**APPLICATION FOR  
URBAN DESIGN COMMISSION  
REVIEW AND APPROVAL**

PROJECT ADDRESS: 25 W. MAIN ST., MADISON, WI 53703

# PROPOSED CHANGES TO THE REDEVELOPMENT OF ANCHOR BANK

submitted as a minor alteration to previously  
approved conditional use by the City of  
Madison and the Urban Design Commission

# IV. THE PARKING EXIT STAIR ALONG CARROLL STREET HAS BEEN REWORKED

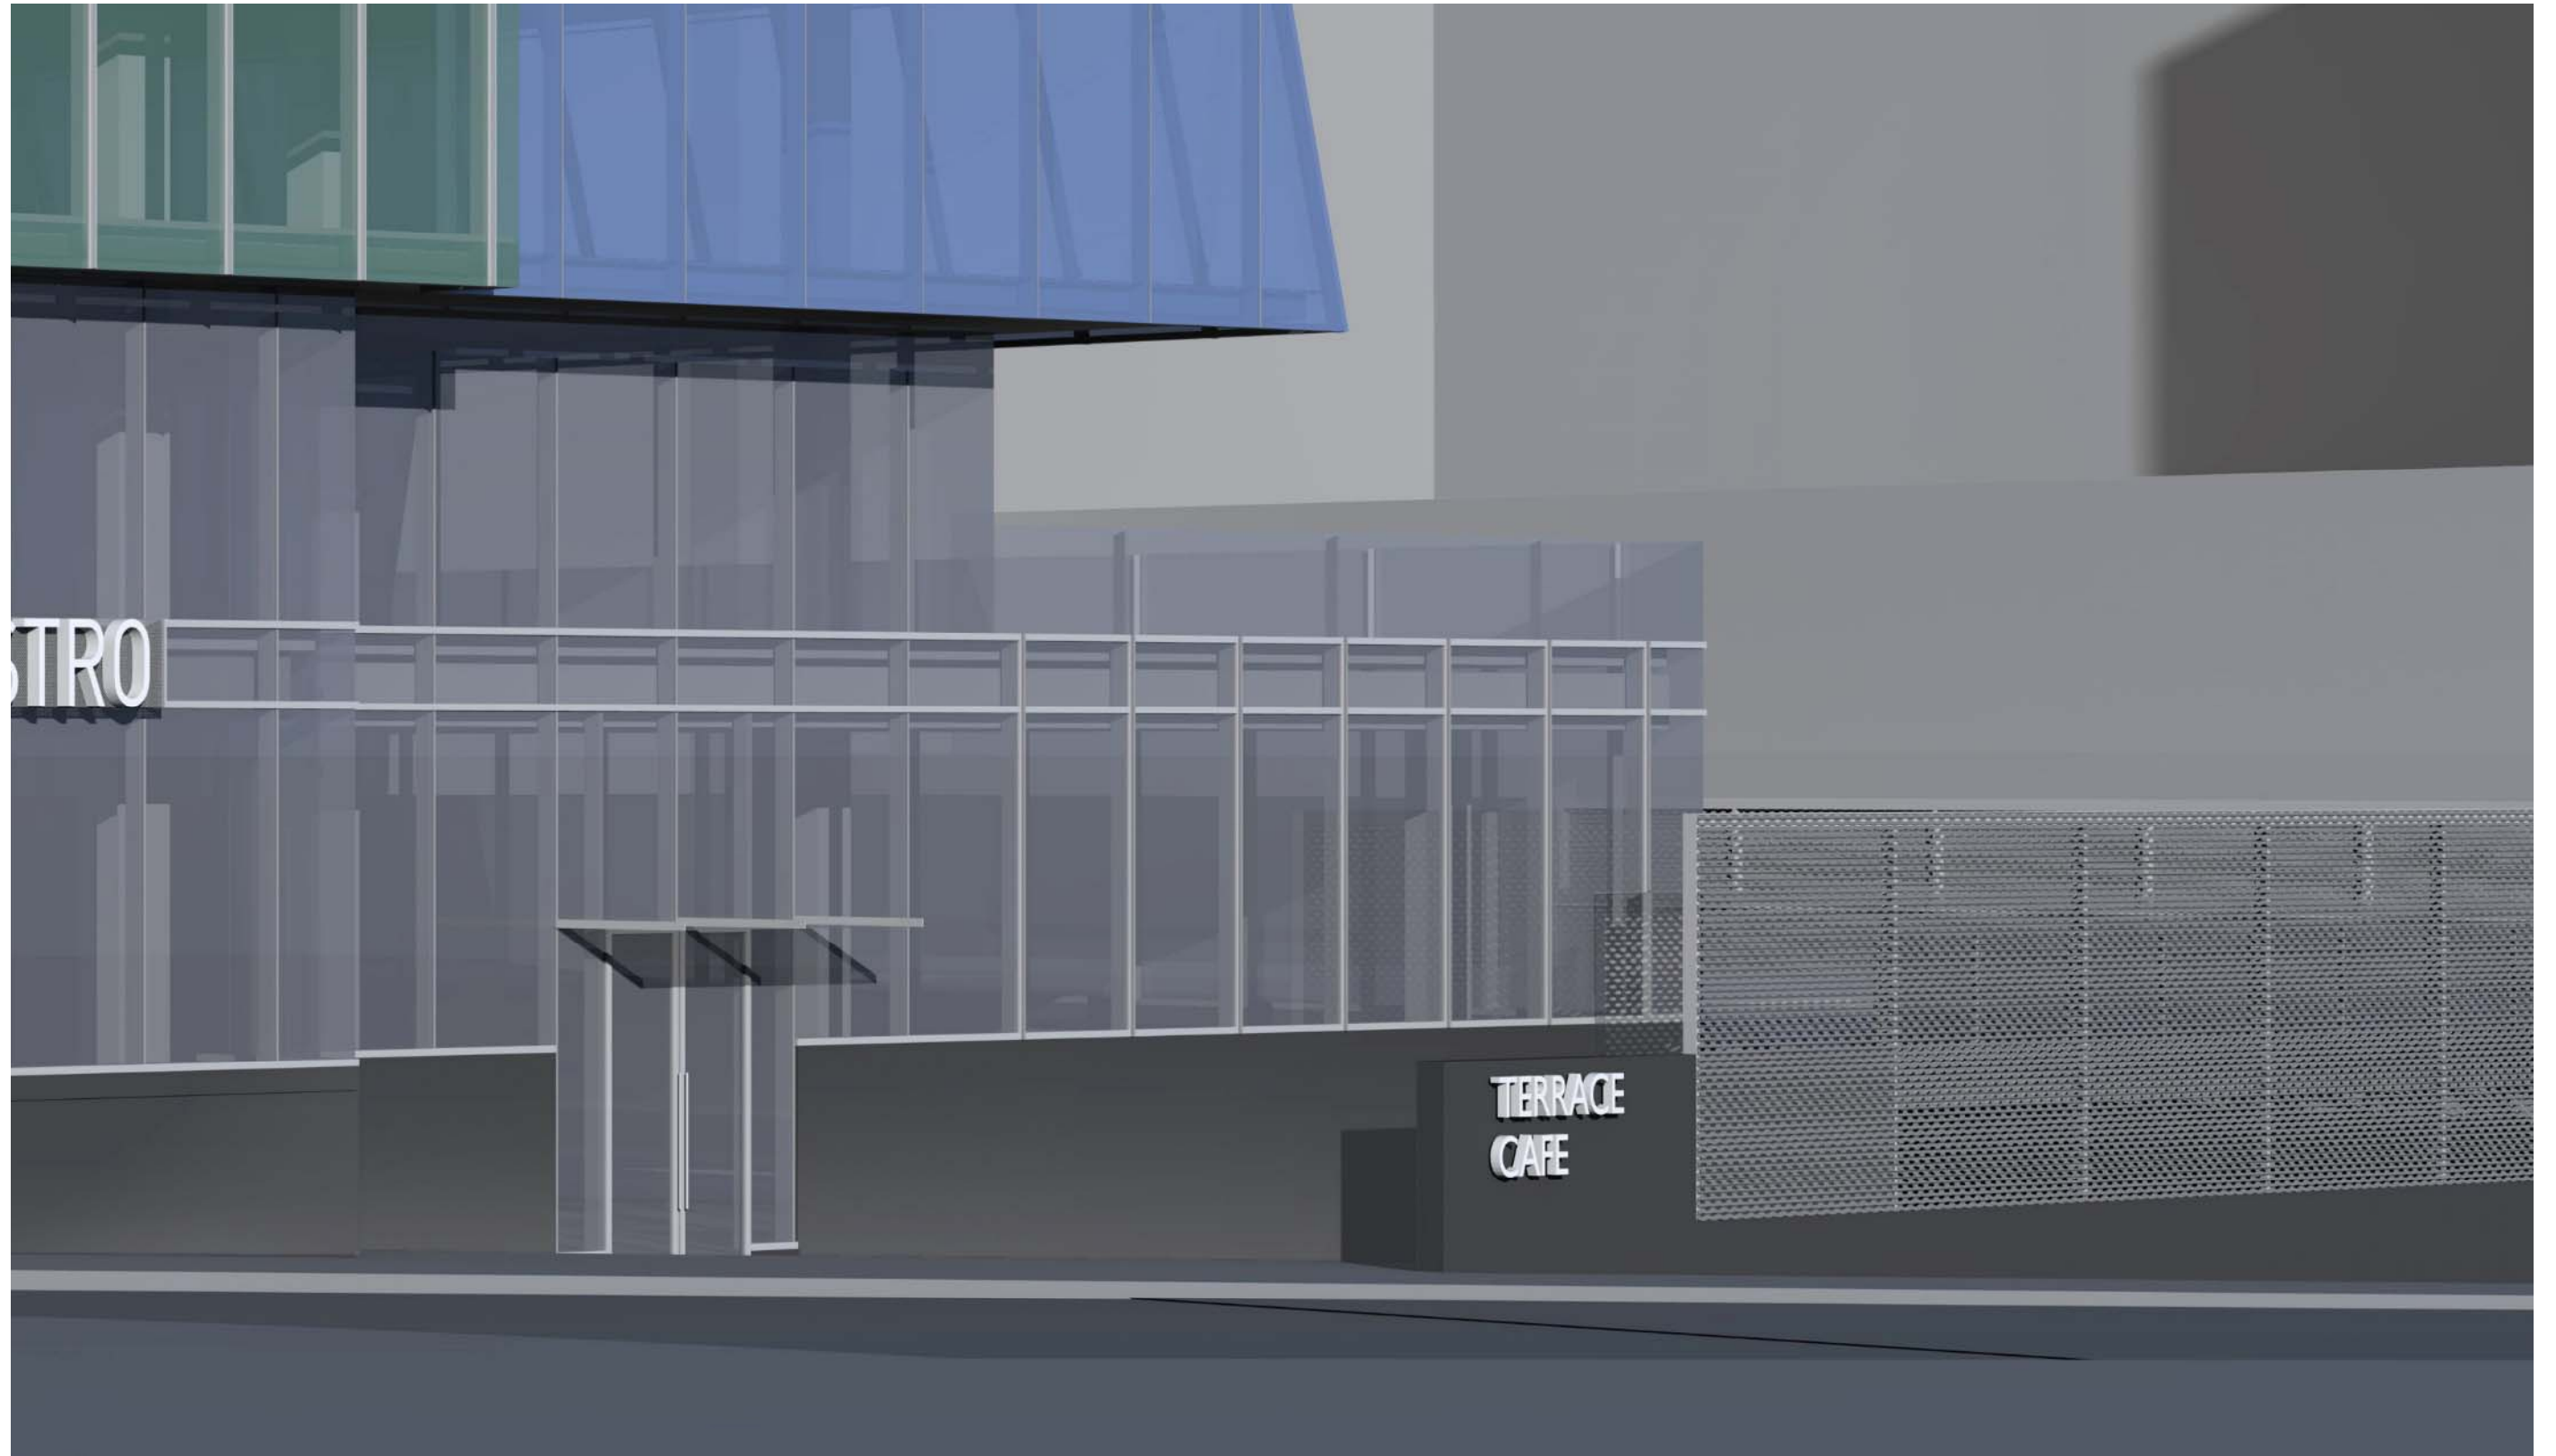
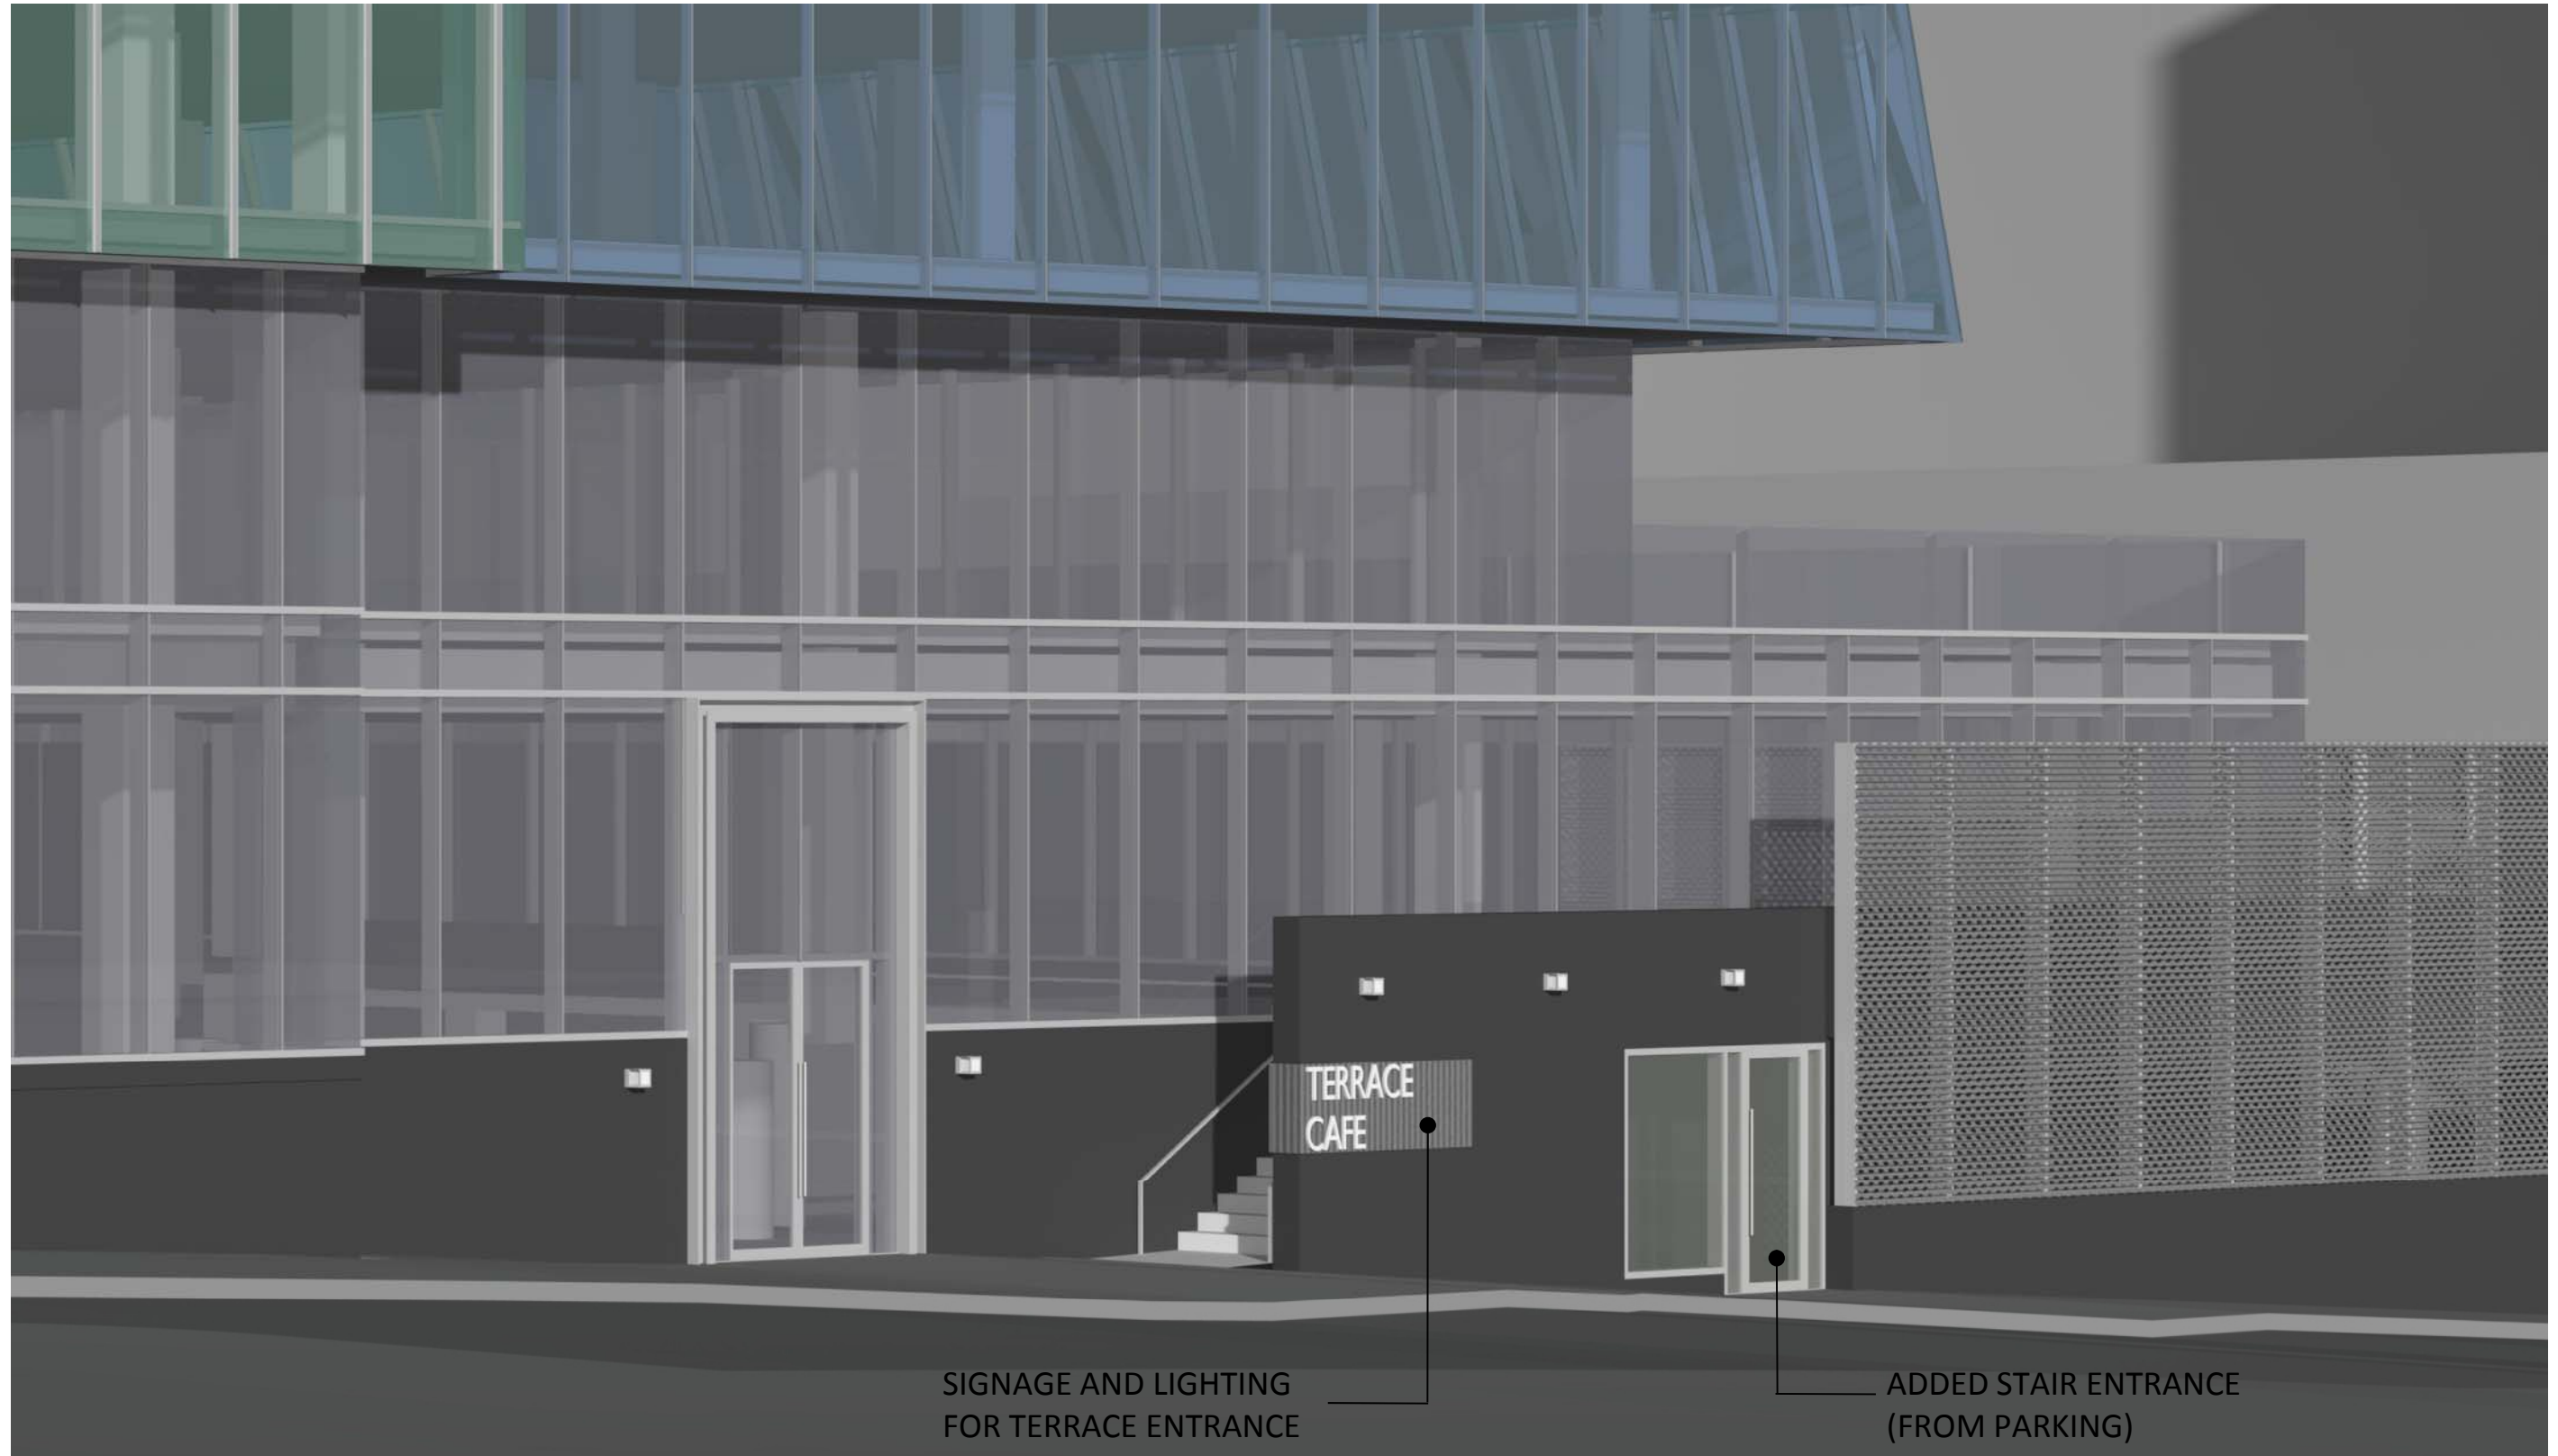
The former stair design created an exit into the existing tunnel underneath Carroll Street, which would have been confusing to evening and weekend users and compromised building security. Because the exist stair doors from the parking ramp need to always open, the warm tunnel would have been a magnet for the homeless during cold weather.

The new stair configuration exits at the sidewalk on Carroll Street immediately adjacent to the new restaurant entrance and will be far easier and safer for after-hours use by people who do not park at the ramp every day.

# CARROLL ENTRANCE DETAIL

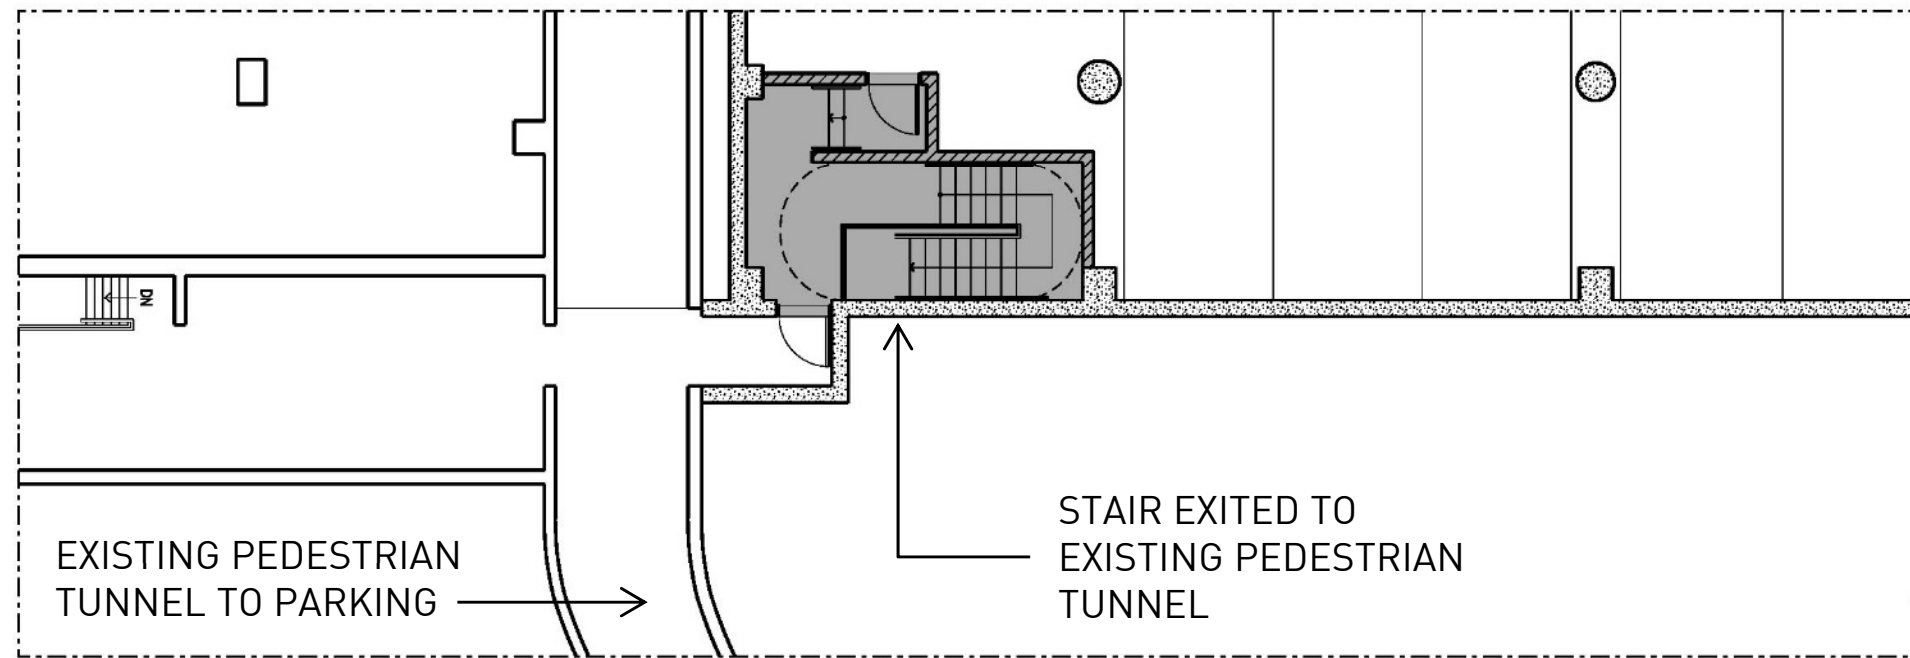
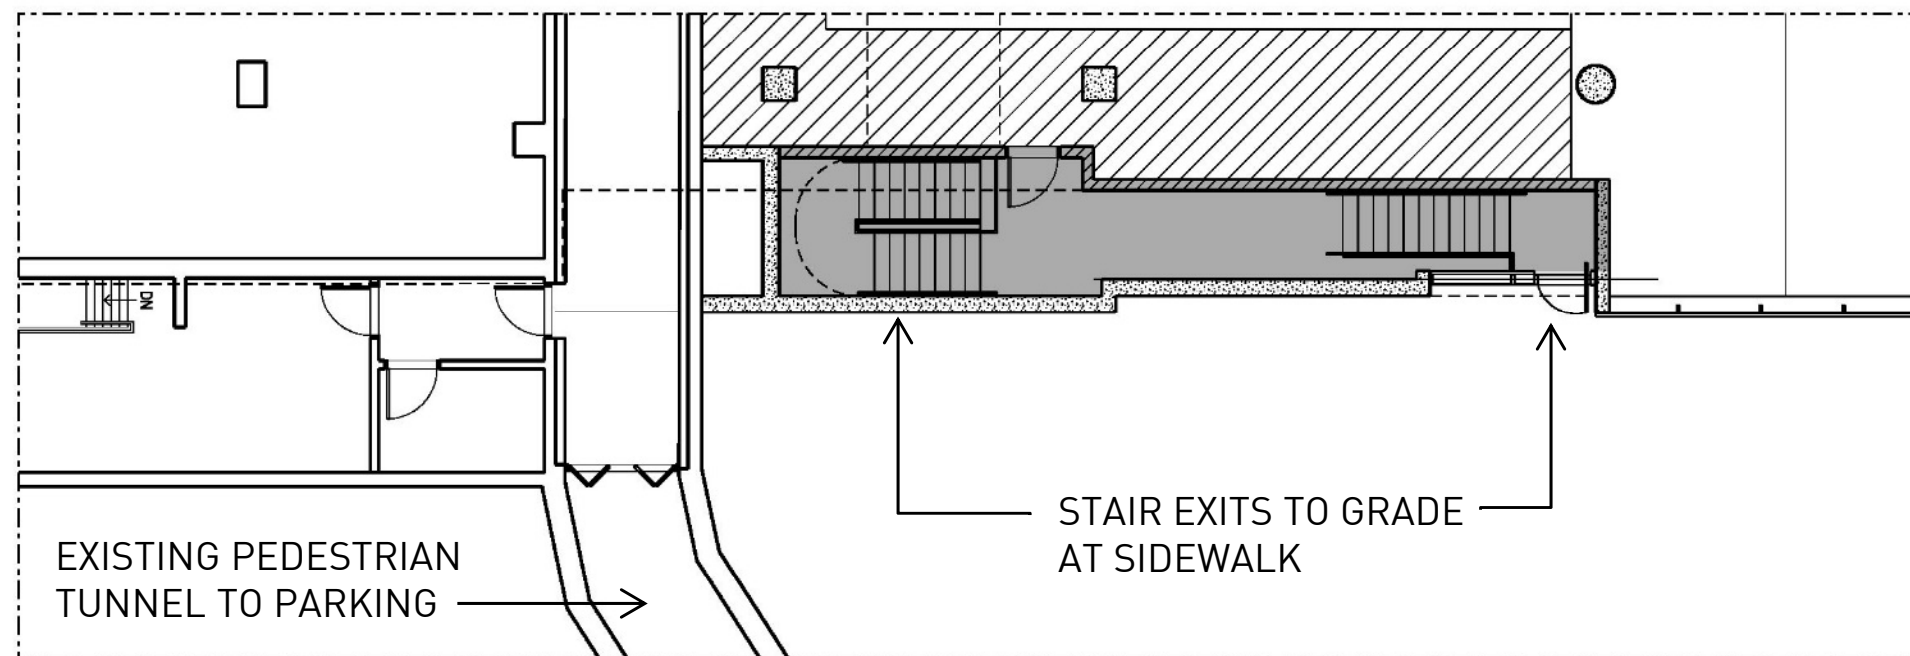
PREVIOUSLY APPROVED

NEW PROPOSAL
